Staff Report to the Western Weber Planning Commission

Application Request:	Consideration and action on a request for final approval of Winston Park Cluster Subdivision.
Type of Decision:	Administrative
Agenda Date:	Tuesday, July 11, 2017
Applicant:	Jaymak Ogden, LLC
File Number:	LVW040717

WINSTON PARK SUBDIVISION

Exhibit A

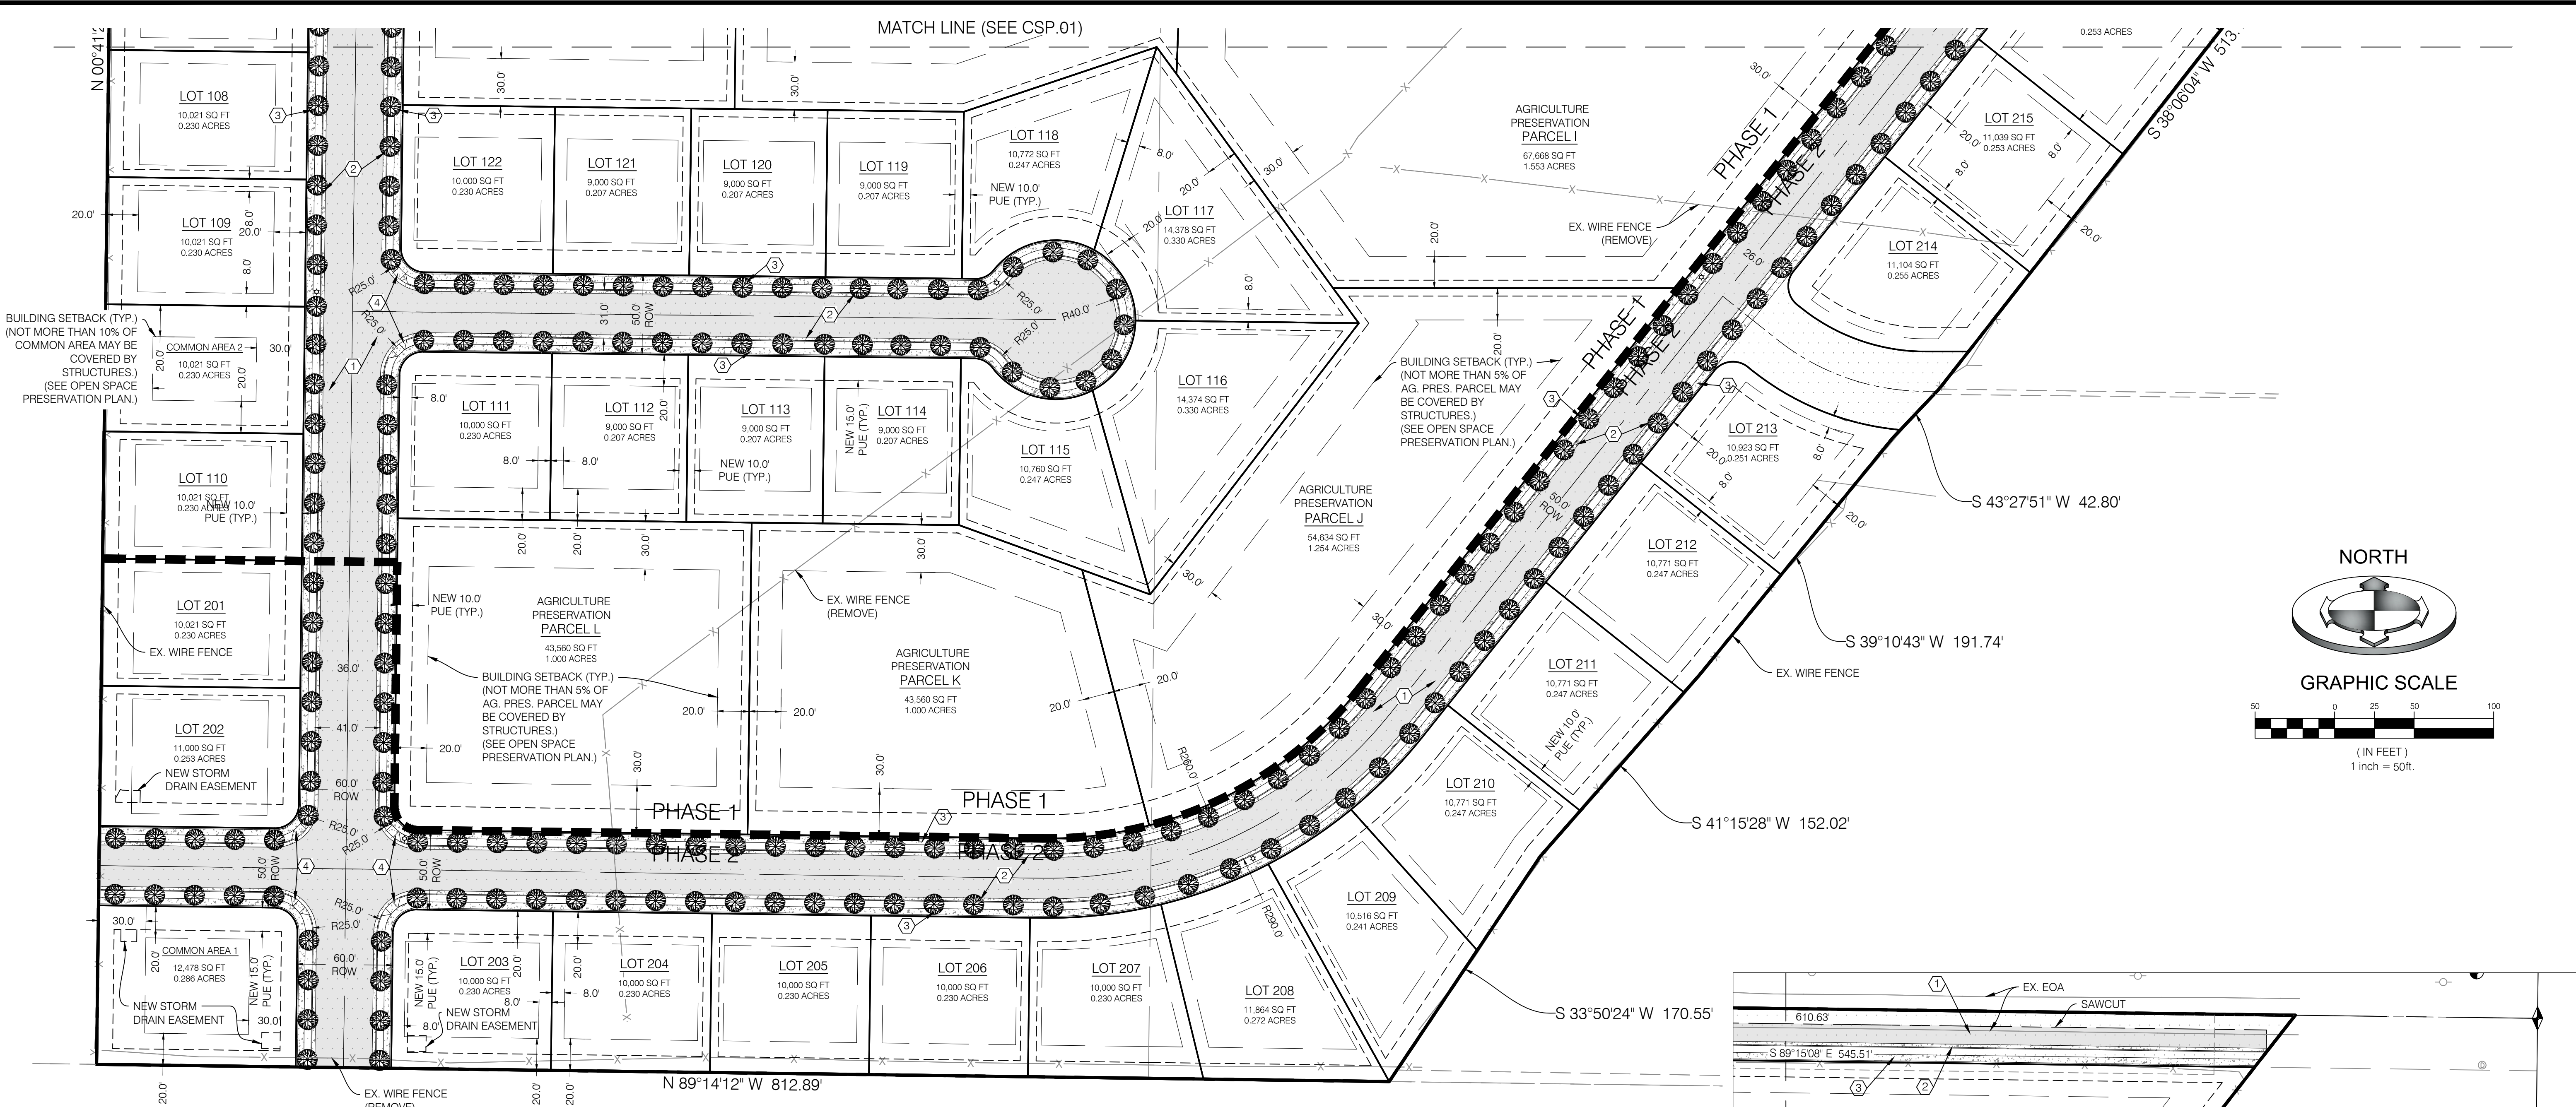
During the Western Weber Planning Commission meeting held on June 13, 2017, the Commission had concerns with retention pond easements located on open space parcels that are to be individually owned by owners of lots within the subdivision. The Commission questioned whether or not the Land Use Code allows improvements such as retention ponds to be located on individually owned open space parcels.

The Commission also had concerns with ownership of the individually owned agriculture preservation parcels and felt unsure about recommending final approval without knowing how the applicant can ensure that the owners of the agriculture preservation parcels remain owners of lots within the same subdivision.

LUC §108-3-5 states that the ownership standard (Individually owned preservation parcels of less than ten acres in area may only be owned by an owner of a lot within the same cluster subdivision) shall be memorialized by placing a note on the final plat, explaining the ownership standard. A note on the plat would allow the county to enforce this standard by not approving land use permits for either the residential lots or the agriculture preservation lots if the ownership is not the same. A condition of approval has been added to the staff recommendation to ensure the note is placed on the final plat.

A storm water plan is required as part of the preliminary and final subdivision application. The applicant is currently working with the County Engineering Division to ensure that the plan meets Engineering requirements. The Land Use Code does not prohibit improvements such as retention ponds to be located within individually owned open space parcels. The Open Space Preservation Plan addresses how these parcels are to be used and maintained. The plan specifically states that no crops are permitted on parcels A, B, and D in order to protect the retention ponds. The plan also prohibits buildings on parcel A for the same reason. Parcels B and D have enough area not affected by retention pond easements to allow agricultural structures, as allowed by the open space plan. The open space plan allows animal grazing on all parcels affected by retention pond easements.

6. A note describing the applicable ownership standard shall be placed on the final recorded plat, as outlined in LUC §108-3-5 (2).

UTILITY PLAN

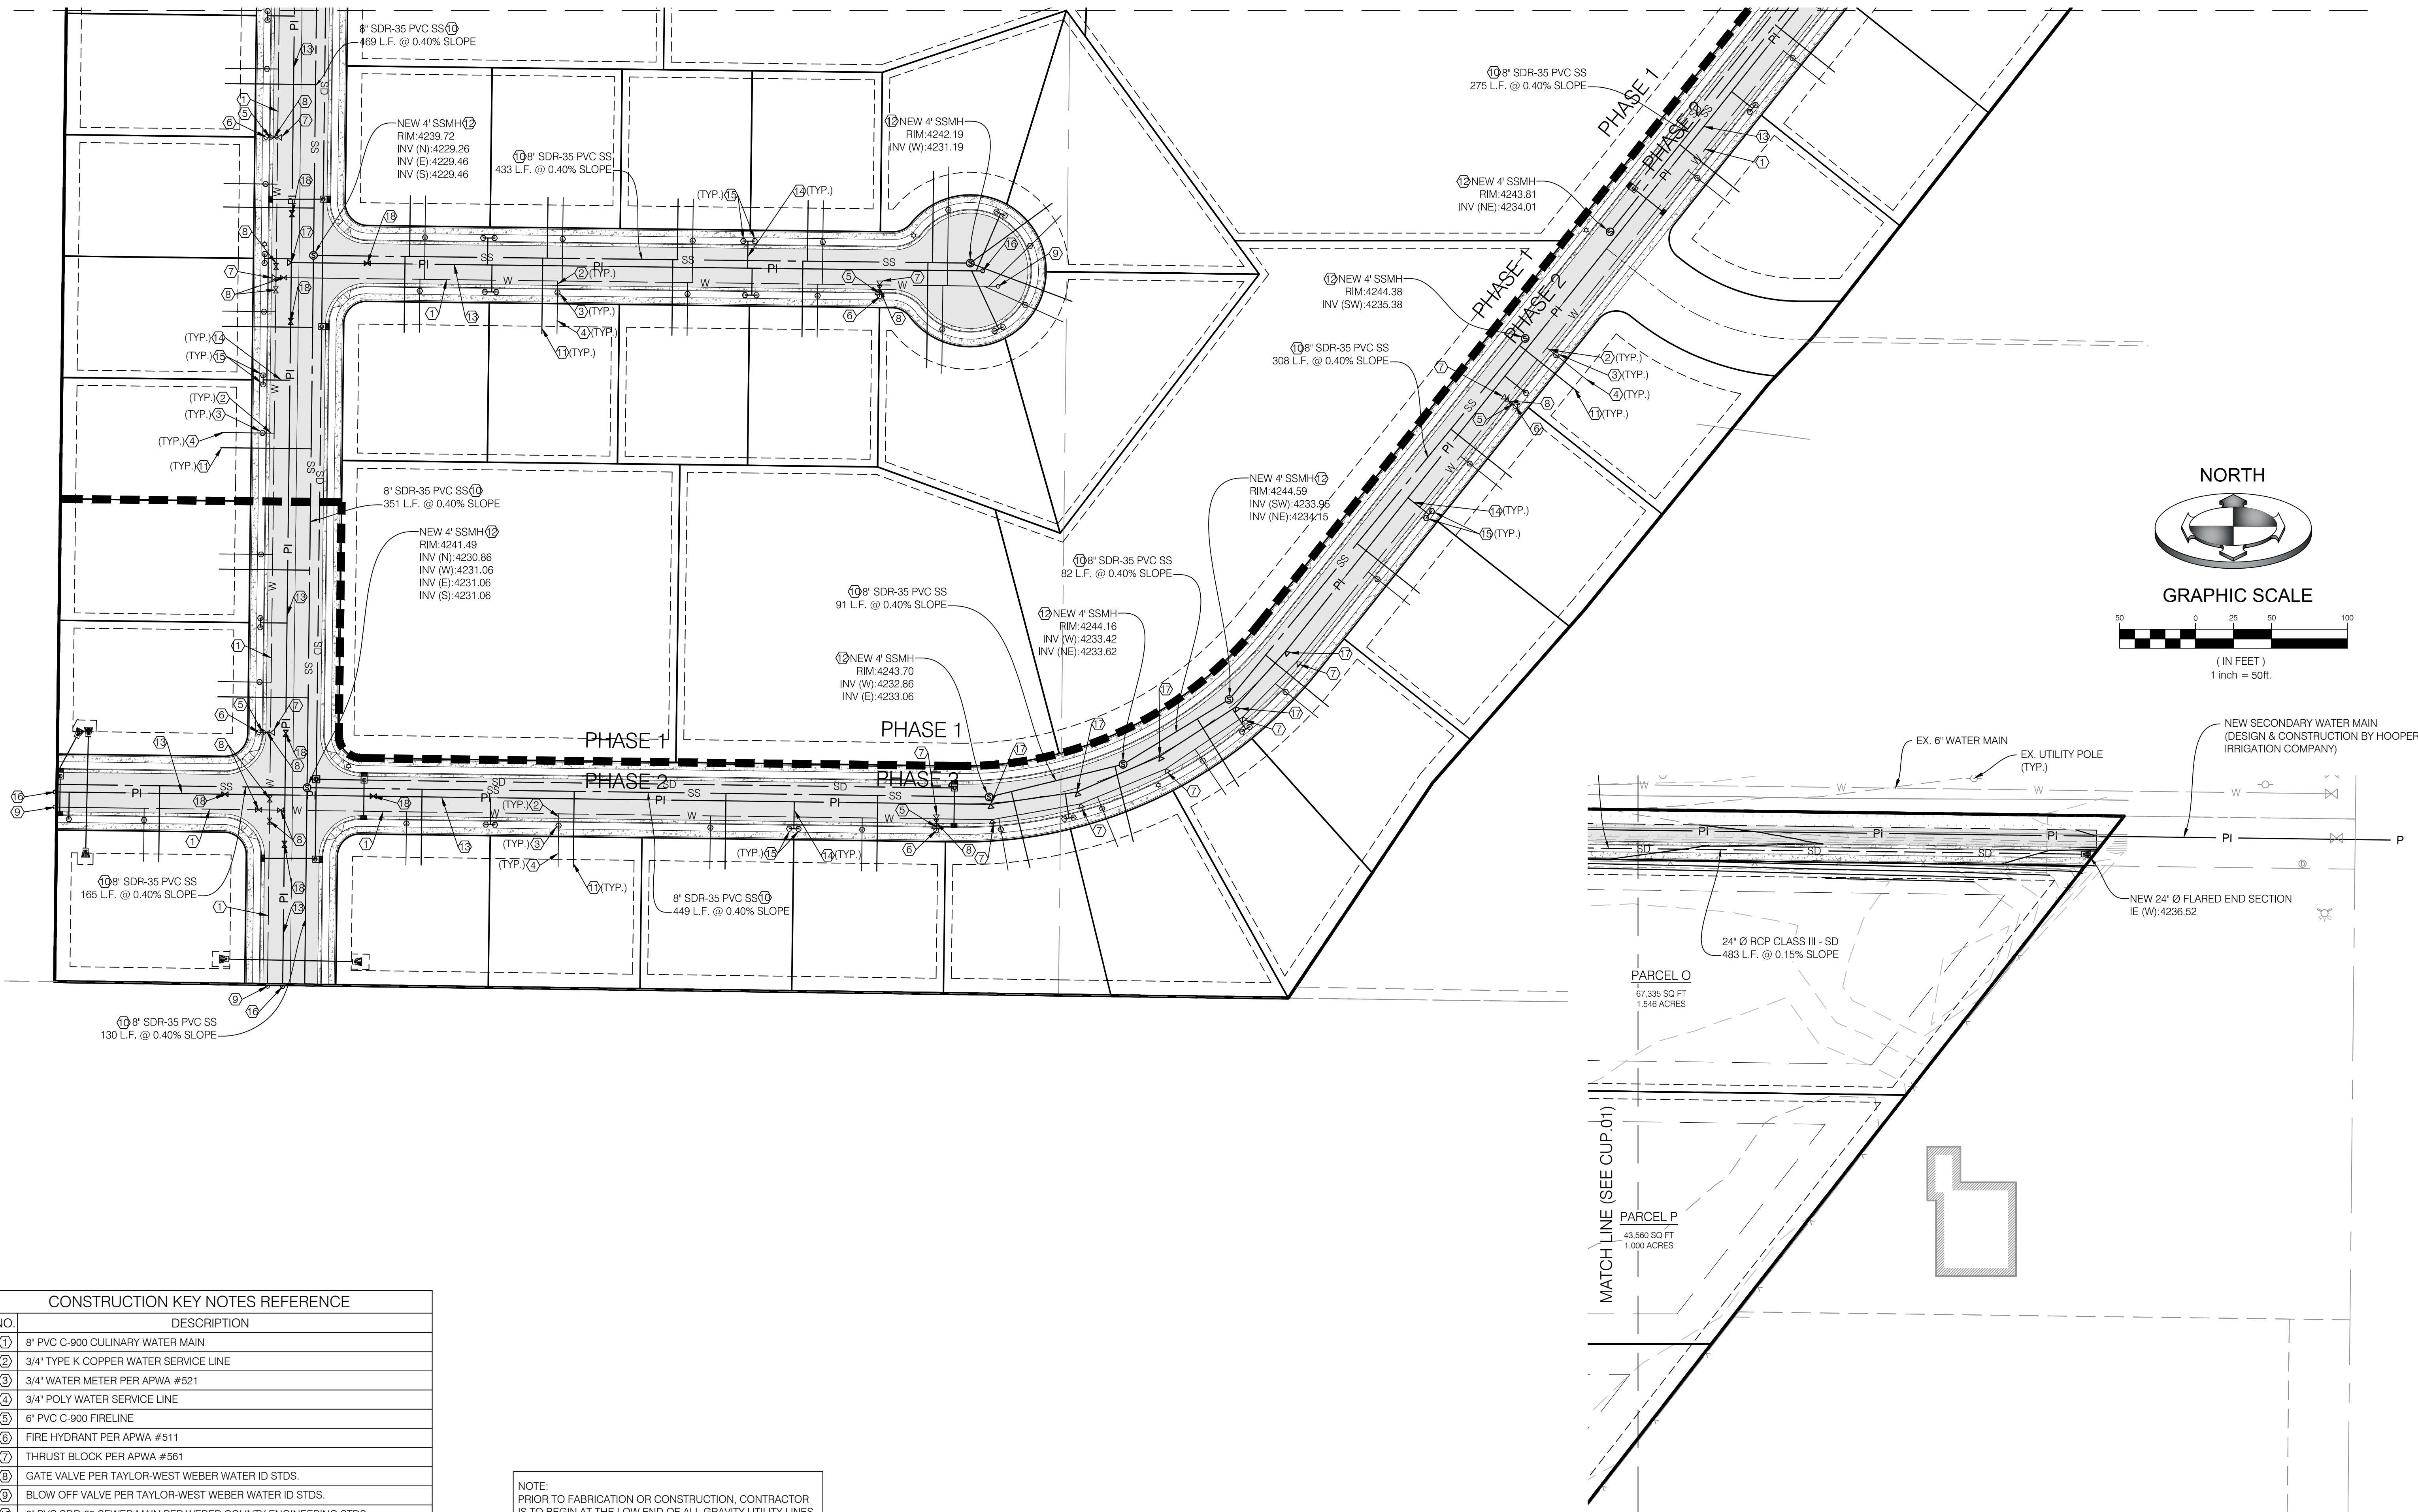
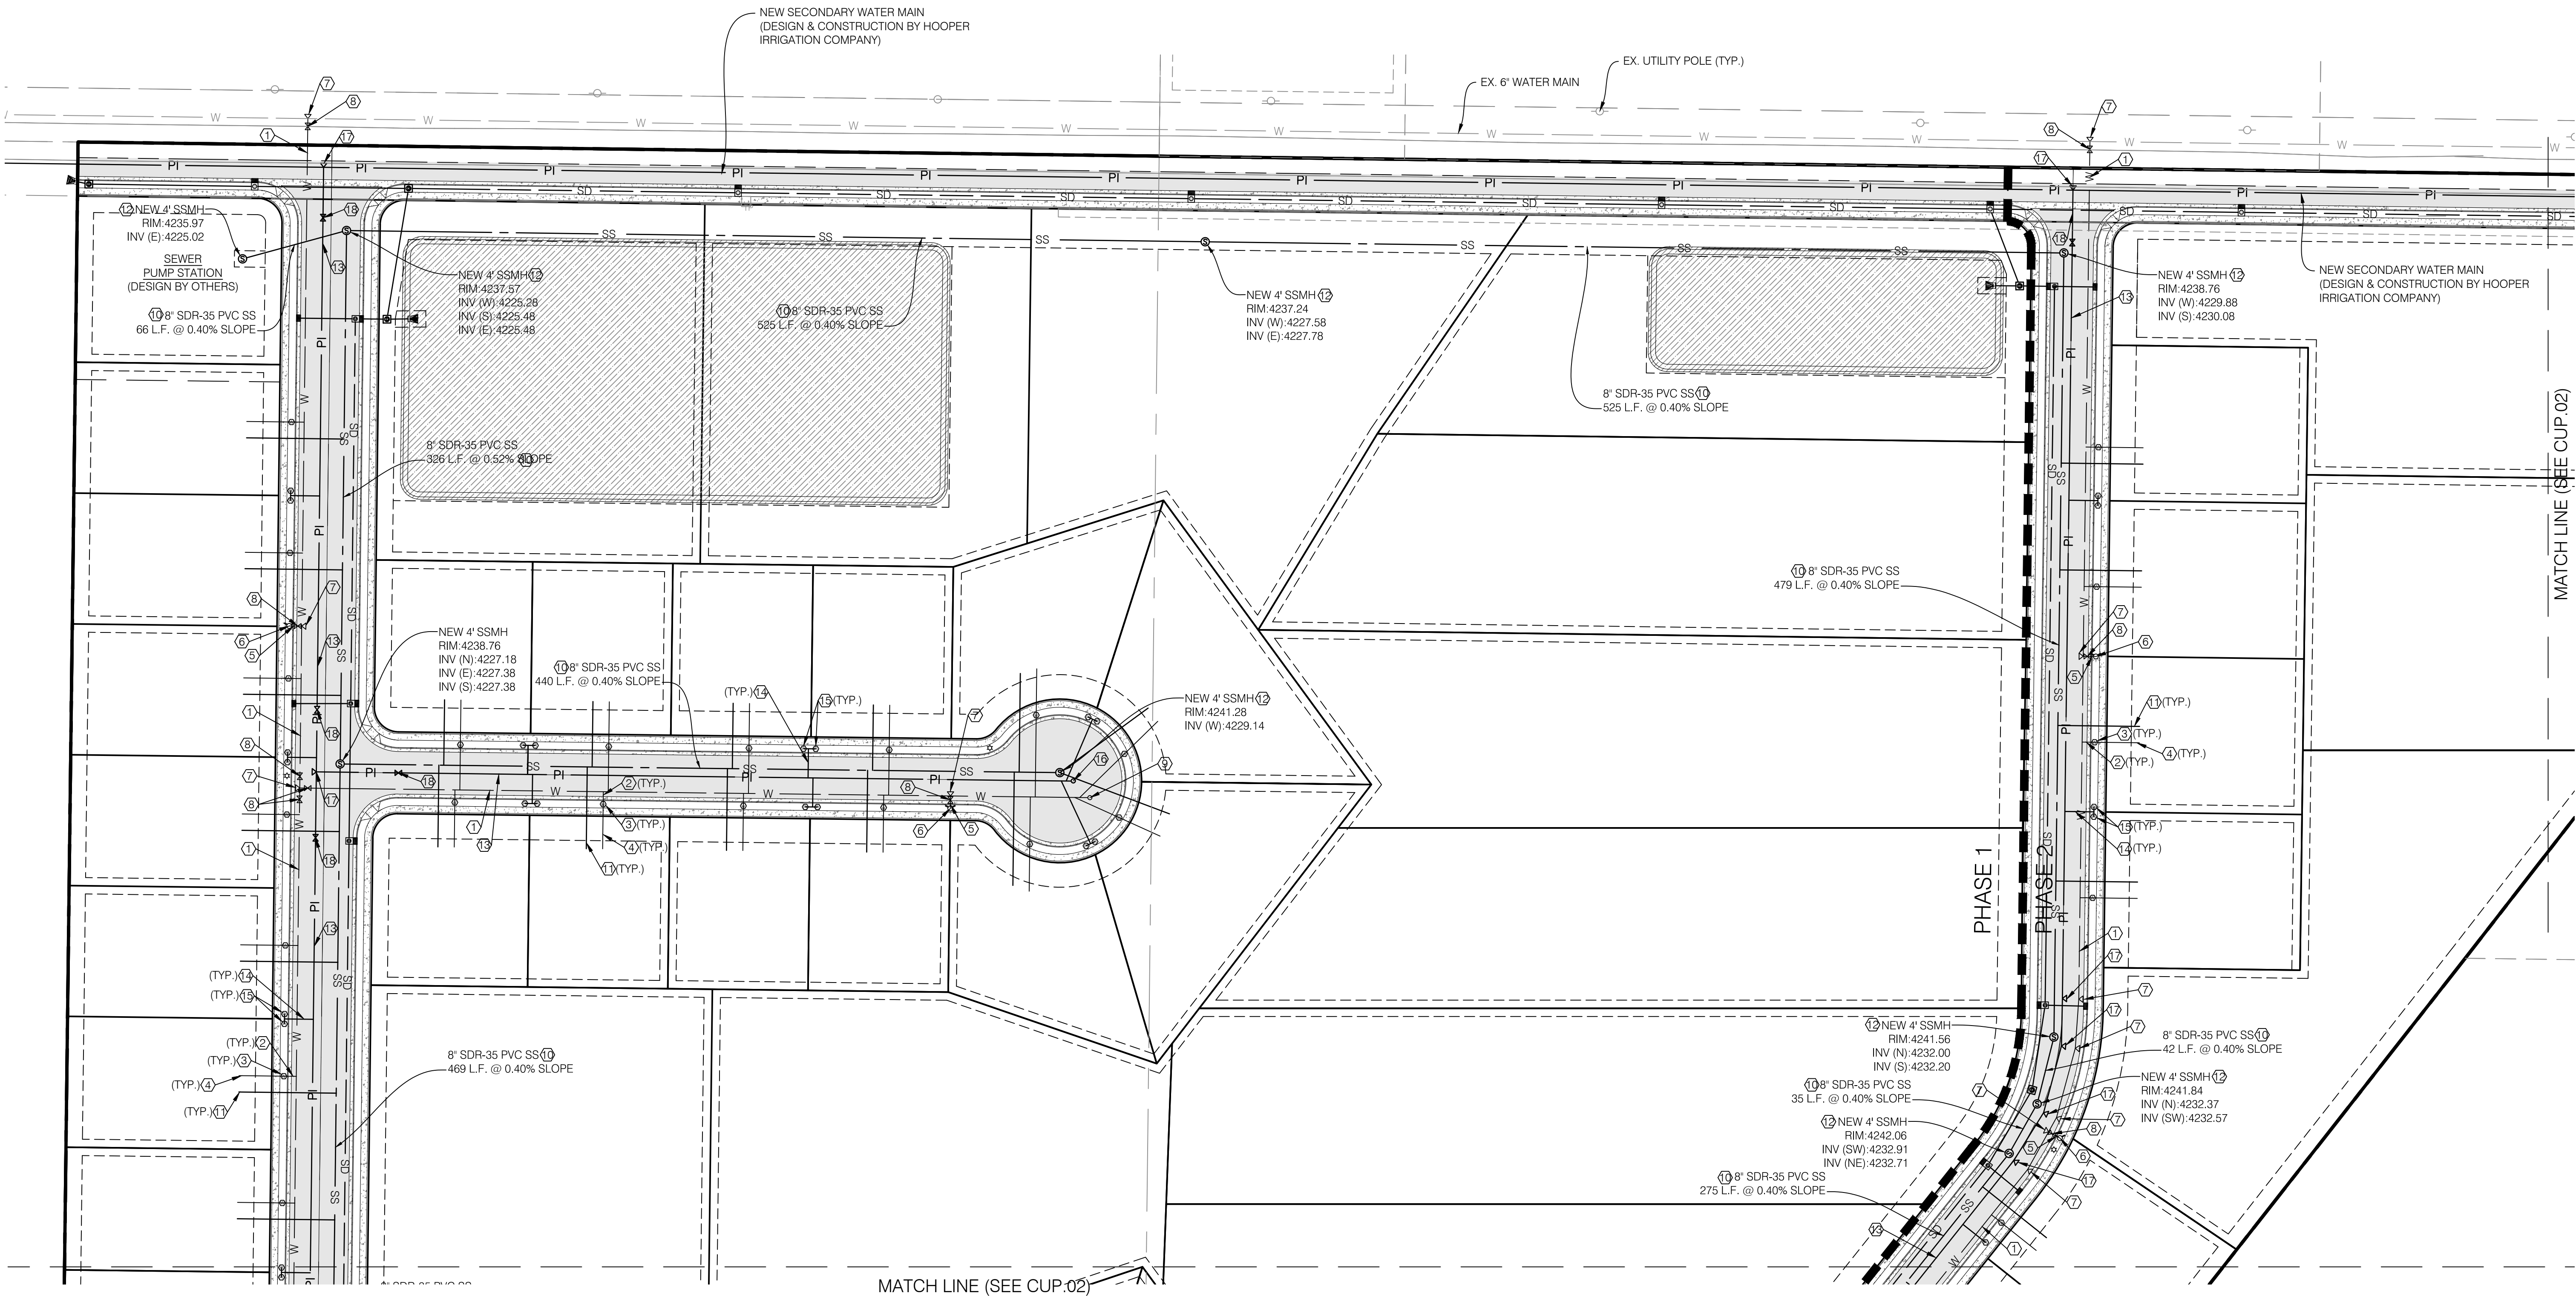
1. The District does not have a gravity flow sanitary sewer line at this location. The closest lines to serve this area are either at the intersection of 1800 South 4300 West or due south of the proposed subdivision on 2200 South. The preliminary utility plans show a sanitary sewer pump station to be constructed in the northwest corner of the subdivision. The connection point from the discharge of the pump station to the District's line is not shown.

3. The District will need to review the location and engineered detail of the point of connection to the District's sanitary sewer lines.
4. The utility drawings indicate a sanitary sewer line being constructed through Agricultural Lots A through E. While the District will not own or maintain these lines we feel there should be a dedicated easement provided to either the County or an entity that will have ownership responsibility for this sewer line.

5. Manholes through the agricultural lots should be raised manholes so groundwater, irrigation water and/or storm water does not enter into the sanitary sewer system. No

buildings or structures should be constructed over the sewer line or within the easement that runs through the agricultural lots.
